LEE'S SUMMIT
MISSOURI
Development Services Department

Development Services Staff Report

File Number	PL2025-207
File Name	PRELIMINARY DEVELOPMENT PLAN – East Village Phase 1
Applicant	East Village Investors, LLC
Property Address	Approximately 130 gross acres generally located at the southeast corner of the intersection of US 50 Hwy and South M-291 Hwy
Planning Commission Date	November 13, 2025
Heard by	Planning Commission and City Council
Analyst	Hector Soto, Jr., AICP, Senior Planner

Figure 3 - Proposed monument sign locations.

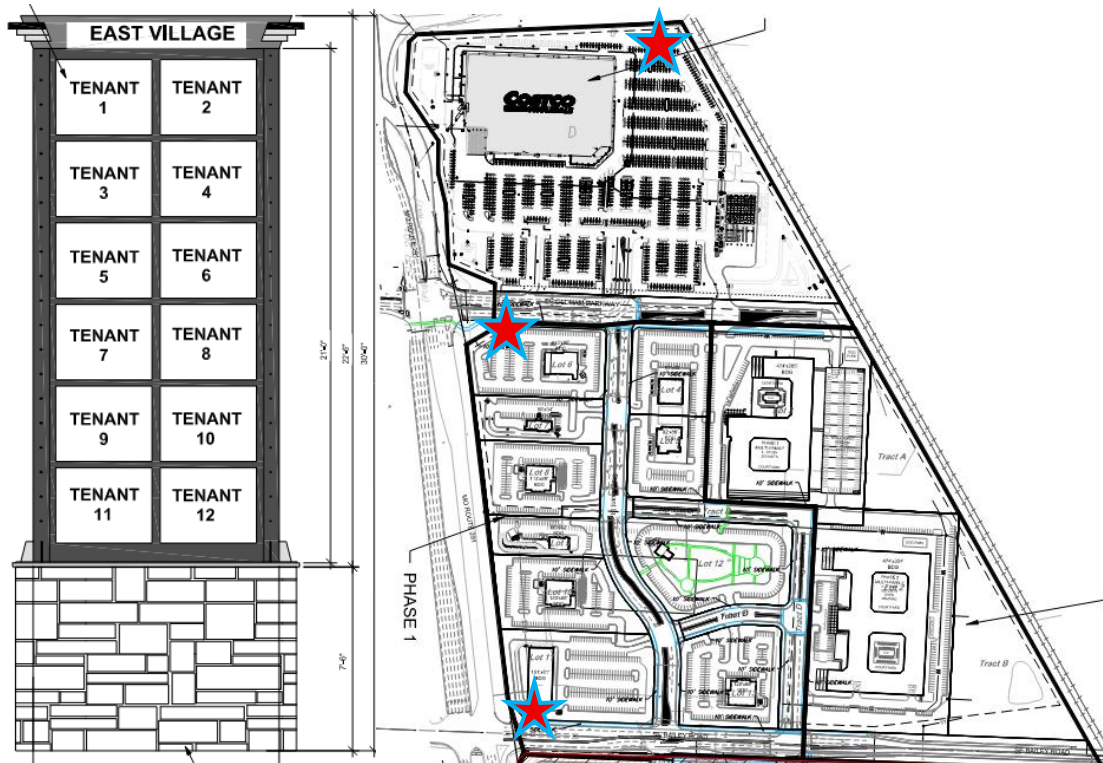
The applicant proposes an allowance for oversized monument signs, as described above, along its two highway frontages to provide a primary means of identification and wayfinding for the development near the intersection of two highways. The City Council relatively recently approved two (2) identical oversized signs for the Oldham Village development on the west side of South M-291 Hwy for the intersection of the South M-291 Hwy and SW Oldham Pkwy, and for the northwest boundary of the development facing US 50 Hwy. The City Council has also relatively recently approved two (2) oversized monument signs for a similar commercial development (Summit Orchards North) having a height of 45' and an overall sign structure size of 637.5 sq. ft. along the project site's I-470 highway frontage. Staff supports the applicant's proposal for taller and larger monument signs along the highway frontages as depicted below.

9. Approval shall be granted for three (3) oversized, primary identification monument signs in East Village Phase 1 with an overall height of 30', 224 sq. ft. sign face area and 312 sq. ft. overall sign structure area to be located at the northeast project site boundary, the southeast corner of South M-291 Hwy/SE Oldham Pkwy, and the northeast corner of South M-291 Hwy/SE Bailey Rd as depicted on the preliminary development plan October 30, 2025, and monument sign detail dated August 7, 2025.

Figure 4 - Elevation showing wall signage (east and partial southeast façade)

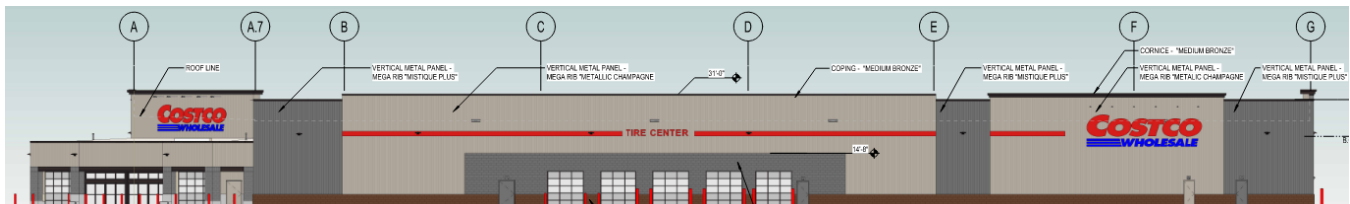
The table below outlines the characteristics of the proposed wall signs for Costco on Lot 1.

10. Approval shall be granted to allow six (6) wall signs on the Costco (Lot 1) building as depicted on the building elevations dated August 8, 2025. All other lots in East Village Phase 1 (Lots 2-13) shall be subject to the governing sign standards and allowances of the PMIX zoning district.

Figure 10 - Traffic Impact Study phase areas

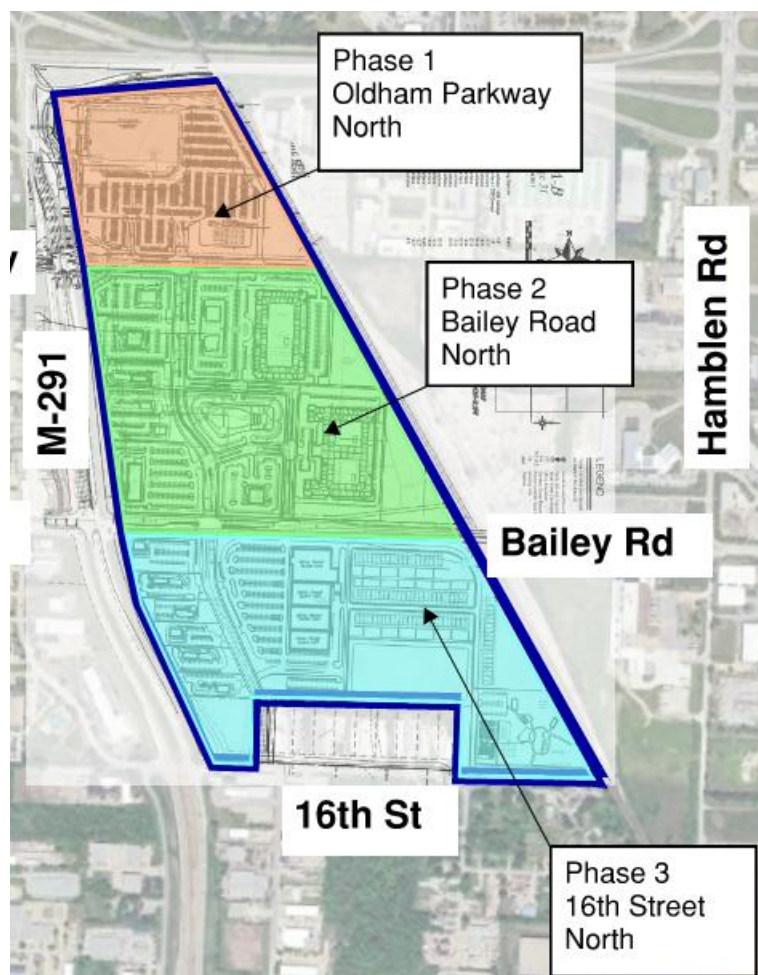
The study recommends construction of certain road improvements in a phased manner tied to sub-areas of the East Village development coming online. For the purposes of the TIS evaluation, the East Village development was divided into three (3) sub-areas. The northern sub-area (identified as Phase 1 in the TIS) lies north of the proposed SE Oldham Pkwy extension and is solely composed of the Costco site. The middle sub-area (identified as Phase 2 in the TIS) is composed of the area bordered by SE Oldham Pkwy on the north and SE Bailey Rd on the south. The southern sub-area (identified as Phase 3 in the TIS) is composed of the area bordered by SE Bailey Rd on the north and SE 16th St on the south. Generally speaking, road improvements to serve East Village will include, but are not limited to, the extension of SE Oldham Pkwy to serve as an east-west commercial collector street along the south side of Costco; construction of a north-south commercial collector street connecting SE Oldham Pkwy to SE Bailey Rd; construction of a north-south street connecting SE Bailey Rd to SE 16th St; signalized intersections along both SE Oldham Pkwy and SE Bailey; and turn lane improvements along SE Bailey Rd and M-291 Hwy. A full list of the specific road improvements are found in the TIS and Traffic Impact Analysis (TIA) prepared by staff and included as an attachment to the staff report.

7. Road improvements for East Village Phase 1 shall be constructed as recommended in the Transportation Impact Analysis prepared by City staff dated October 30, 2025.

Figure 12 - Trash and recycling receptacle area with evergreen landscape screening.

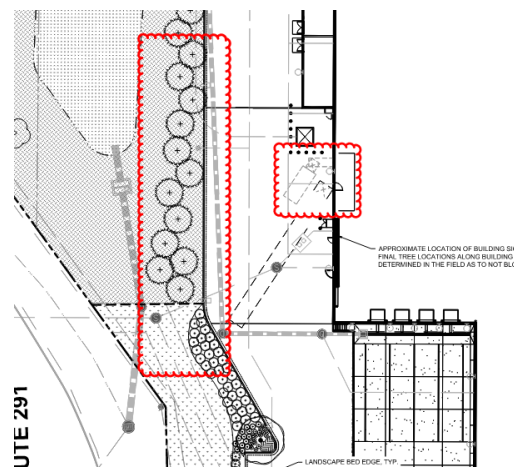
- Proposed – The trash and recycling receptacles located along the west side of the Costco building in the general vicinity of the dock area are proposed with no enclosure. In lieu of an enclosure to house the receptacles, a double-staggered row of evergreen trees and the use of evergreen shrubs along the west parking lot/drive aisle boundary parallel to the receptacles will be installed to screen the view of the receptacles from the South M-291 Hwy frontage.

- Recommended – The applicant's preferred practice for the Costco site is to provide additional evergreen landscape screening of dock areas and trash and recycling receptacle areas rather than constructing structural screens such as masonry walls in areas with high frequency of turning and backing movements by large vehicles (i.e., semis and trash trucks). Staff recommends approval of the modification request.

4. A modification shall be granted to the trash and recycling receptacle screening requirement by a masonry enclosure, to allow screening via the planting of evergreen landscape screening as shown on the landscape plans included in the preliminary development plan in lieu of masonry enclosure screening.
